### Product Change Notice

This document describes a recommended change for the LAN8720 PHY Daughter Board, 04-10163, Rev. 1.0.

# LAN8720 PHY DAUGHTER BOARD

FIGURE 1: LAN8720 PHY DAUGHTER BOARD LAYOUT

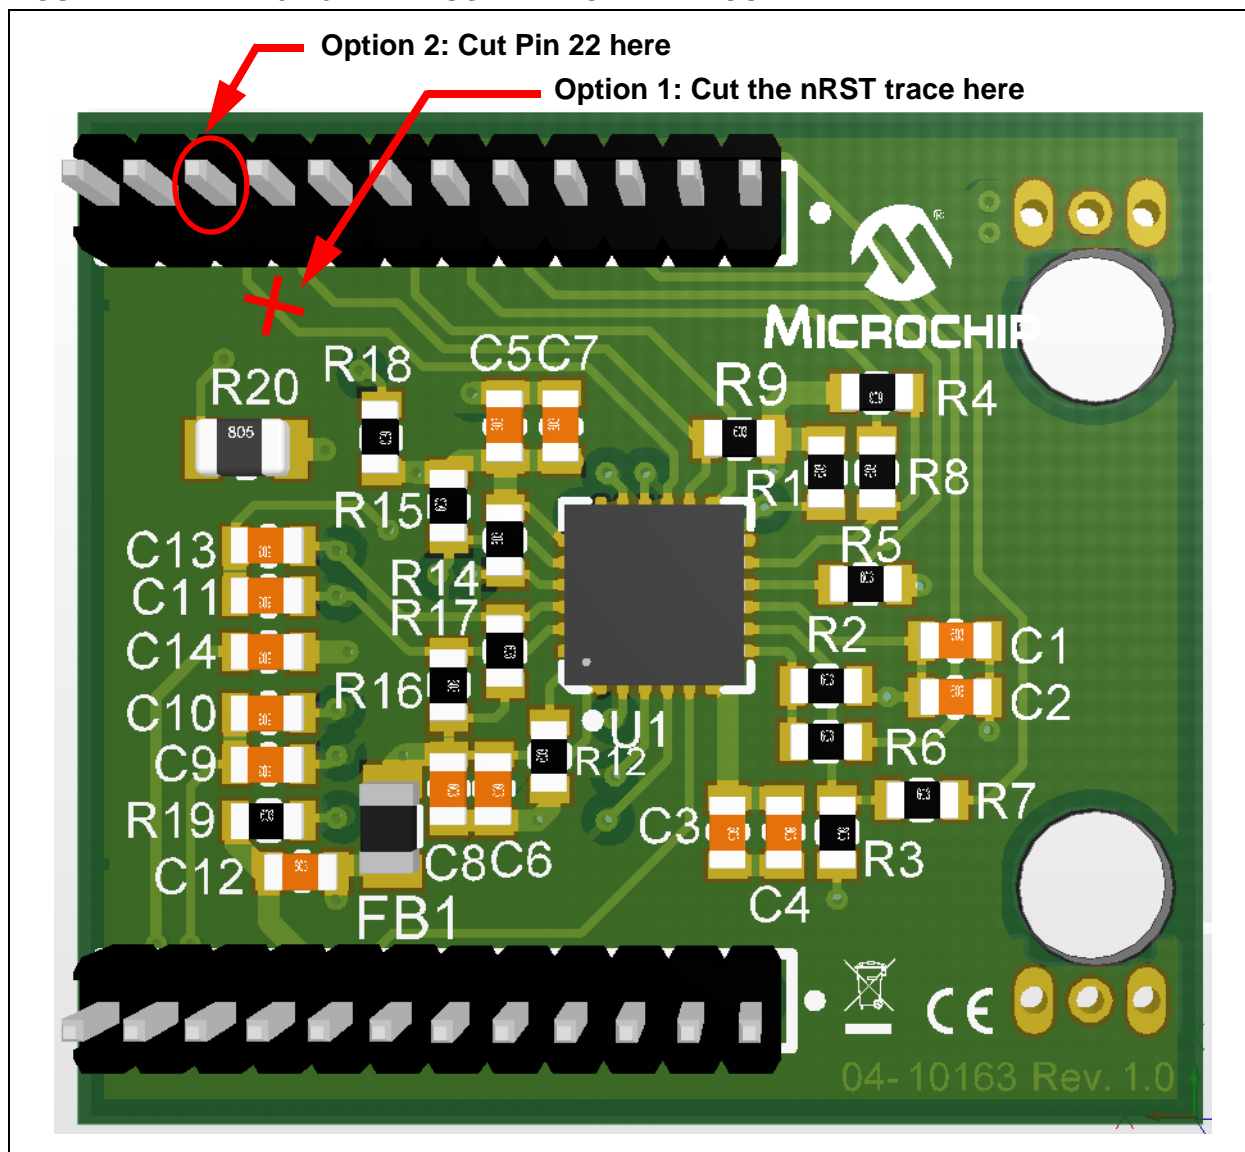
On PIC32 starter kits that utilize this daughter board, the MCLR pin drives the nRST signal of the LAN8720. In some situations, the PHY may enter a latched state during programming/debugging when using either MPLAB® REAL ICE™ or the on-board

debugger. This state may occur as MCLR is driven by these debuggers with specific timing, which may differ from the specification in the LAN8720 Data Sheet.

In the event the PHY communication fails, make one of the following changes, which are shown in Figure 1.

**Option 1:** Cut the nRST trace.

OR

**Option 2:** Cut pin 22.
